WATTS BAR NUCLEAR PLANT (WBN) - ADDITIONAL DIESEL GENERATOR (TAC NO. 63606)

This letter provides TVA's response to NRC's request for additional information (RAI) dated July 28, 1986, concerning WBN's emergency diesel generator systems, the additional diesel generator system, and the buildings associated with these systems. The RAI included 18 questions for TVA to answer. Furthermore, one of these questions (Question 040.129) identified another 50 previously answered questions that might require updated responses to address any differences or unique aspects of the additional diesel generator and its building in comparison to the other diesel generators and their buildings. The RAI requested a response in a timeframe consistent with WBN's fuel load date.

REQUEST FOR ADDITIONAL INFORMATION
WATTS BAR NUCLEAR PLANT, UNITS 1 AND 2
DOCKET NUMBERS 50-390 AND 50-391

SCHEMATIC DIAGRAM LUBE OIL
 SYSTEM
 DRAWING NO. 6036F03001
 FIGURE NO. Q40.128-2

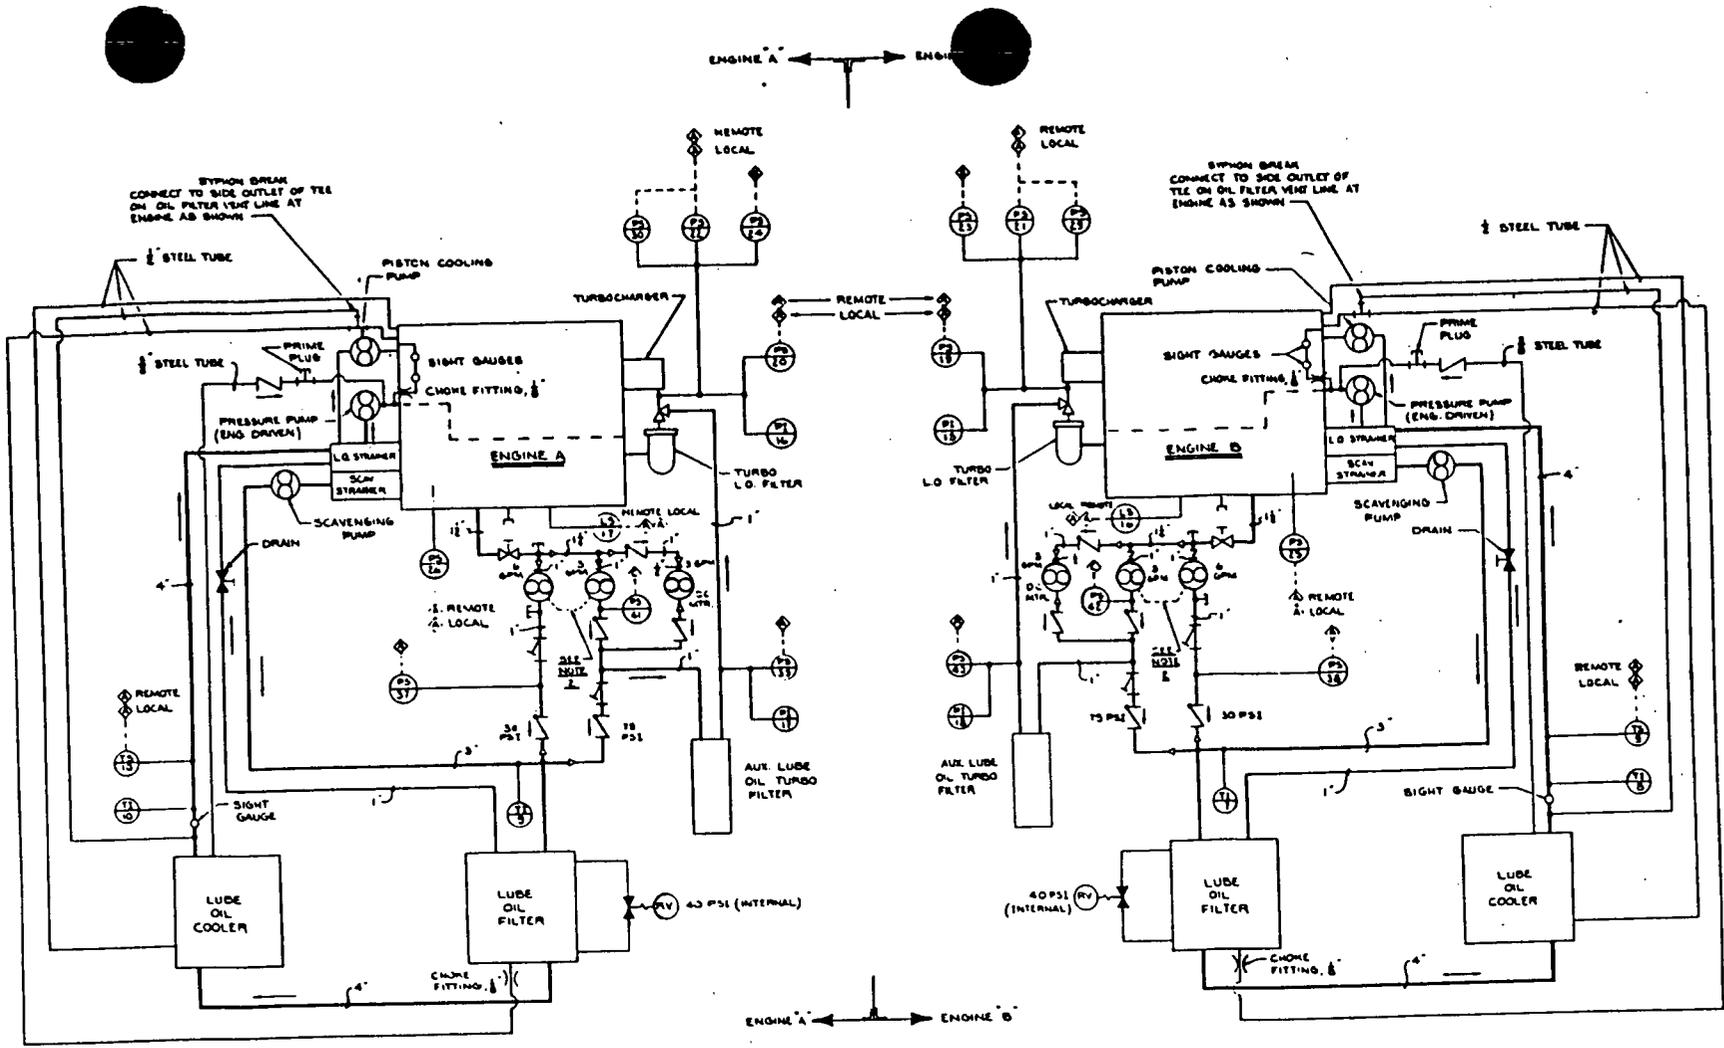
1. Diagrams and drawings in the maintenance manuals show the main bearing pump lube oil system providing lubrication to the camshaft rocker arm assembly and other upper engine wearing parts except the cylinders and pistons. The M.I. 9644 mods provide a continuous 'Trickle' flow to the main bearing pump system. Indicate whether this trickle flow is sufficient to provide lubrication to the upper engine parts and the means used to prevent the oil from lubricating these parts during standby conditions. Also, provide a description with the appropriate diagrams of the lubrication system in the engine.
2. Several applicants have proposed to provide manual or automatic intermittent prelubrication for the entire engine. This lubrication would

be for a few minute (less than 10 minutes) a day or a week. Does TVA propose to provide this prelubrication? If not, does TVA or the manufacturers have any problems with this proposal in light of the manufacturer's prelube recommendation? If so, discuss the objections.

3. (a) If TVA proposes to modify the engines using that proposed in EMD-GM's M.I. 9644, show how this modification will not cause undue wear to the failure to start over the lifetime of the plant for both emergency and periodic test starts. In your response, consider the NRC's concerns on dry starting and the manufacturer's concern on undue wear on high speed emergency engine starting.

(b) If TVA does not propose to provide the modifications of 3(a), state how TVA will prevent undue wear to the upper engine parts, degradation of engine reliability, or diesel engine failure to start considering the conditions stated in 3(a).

The engine lubricating oil system is a combination of four (4) separate systems for installation with turbocharged engines. For a detailed schematic of the lube oil system supplied on these engines, refer FSAR Figure 40.128-2.

The lube oil circulating pump draws oil from the oil pan and pumps it through a 30 psi check valve, in-line wye strainer, main lube oil filter, lube oil cooler, and is returned to the oil pan through the strainer housing. This system also serves to continuously prelube the engine, the main engine oil galley stays full and the camshaft area is supplied through a separate exterior line. The pump operates continuously.

B.2 The flow provided by the soakback system constitutes a constant prelubrication of the engine and therefore we propose no intermittent prelubrication. Our supplier, Power System - a Morrison-Knudsen Division, concurs with this proposal.

B.3 We are in the process of modifying the WBN engines per EMD-GM's M.I. 9644 and will have it completed prior to Unit 1 fuel loading. As previously stated, these modifications are designed to reduce lubricating oil system drain-down during standby. By continuously furnishing a small quantity of oil and thereby keeping the system full, an oil film would be maintained on the moving parts without causing leakage into the cylinder or into the exhaust system by introducing oil above the cylinders or due to excessive oil pressure during standby. Leakage into the cylinders could cause a hydraulic lock upon receipt of a start signal whereas leakage into the exhaust system could result in fires as outlined in NUREG/CR-0660, 'Enhancement on On-Site Emergency Diesel Generator Reliability.'
